PRE-APPLICATION REPORT TO COMMITTEE

Case Number 17/1116/PRE

LOCATION: Wembley Youth Centre and former Dennis Jackson Centre,

SCHEME: Proposed demolition of existing community centre and proposed erection of

Extract of the Proposals Map showing the subject site and the hatched area which has been designed as "Open Space"

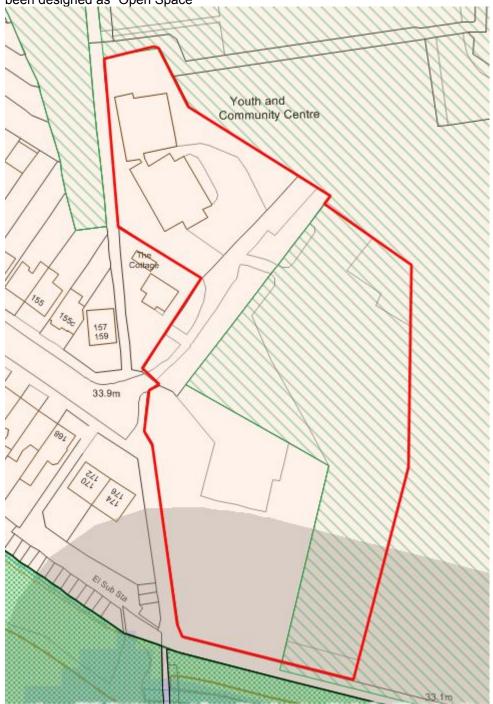
14. The site is not within the Wembley Growth Area or the Wembley Housing Zone and it does not form a part of a site allocation. The site of the Wembley Youth Centre and former Denis Jackson Centre carry no formal specific designations. However, the tarmac land that once formed a part of the school playing fields is included within the area designated as "Open Space" within the Proposals Map.

- 15. Policy CP18 of the Brent Core Strategy sets out that open space of local value "will be protected from inappropriate development and will be preserved for the benefit, enjoyment, health and well being of Brent's residents, visitors and wildlife. This space carries this designation. However, the physical works to change this area to a tarmac parking area were undertaken well in excess of four years ago, and it appears likely that the land may have been used for non-open space purposes for a period of around 10 years. As such, it appears likely that both the physical works and the use of the asphalt land are lawful (in planning terms) and that the proposal would not result in the loss of open space.
- 16. The proposal would include the demolition of the existing Wembley Youth Centre. The loss of community and cultural facilities is addressed through Brent Policy CP23 which

Layout of site including accesses to building

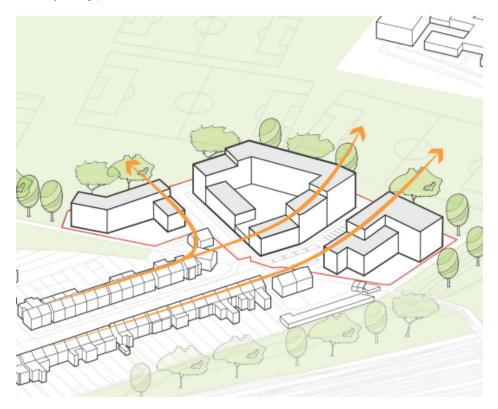
- 28. The development is proposed to be based around two new cul-de-sacs, which the Council would seek for adoption once built. One highway would form a continuation of London Road and terminate at a new public entrance to the playing fields, the other highway would spur off from the continued London Road to the north and would serve the NAIL accommodation block. The private housing block would sit on the corner of these two new highways, whilst the sheltered accommodation block would sit to the south of the continued London Road.

- 29. The applicant would seek to provide off-street parking along the cul-de-sacs and also proposes to activate the highway frontages with individual front doors to ground floor units. The NAIL Accommodation and sheltered accommodation are located in broadly L shaped buildings to the north and south of the site respectively. The private accommodation is located in a broadly circular block in the middle of the site. All of the buildings have a gradient approach to their height, with lower massing on the parts nearest London Road and higher massing on the park edges.

- 30. The private block has a parking podium on its ground floor, which is enclosed and surrounded by the residential block itself. Atop the podium sits a large communal central garden at first floor level. With the exception of the ground floor flats, all units will overlook this communal garden space at the rear.

- 31. Private amenity spaces are only to be provided for the private blocks, with the other tenure blocks relying on separate communal gardens located immediately adjacent to each block.
- 32. The temporary accommodation within the southernmost block will include a ground floor community centre on one of its corners.
- 33. The proposed buildings are three-storey in height where they are situated close to the adjoining suburban dwellings, rising to 6-storeys in height adjacent to the playing fields.
- 34. The scheme looks to mediate the difference in scale between the existing two-storey houses (with pitched roofs) within London Road and this scheme through the use of lower (three-storey) buildings adjacent to the current end of London Road. However, the proposed building heights rise to six storeys on the edge of the playing fields.
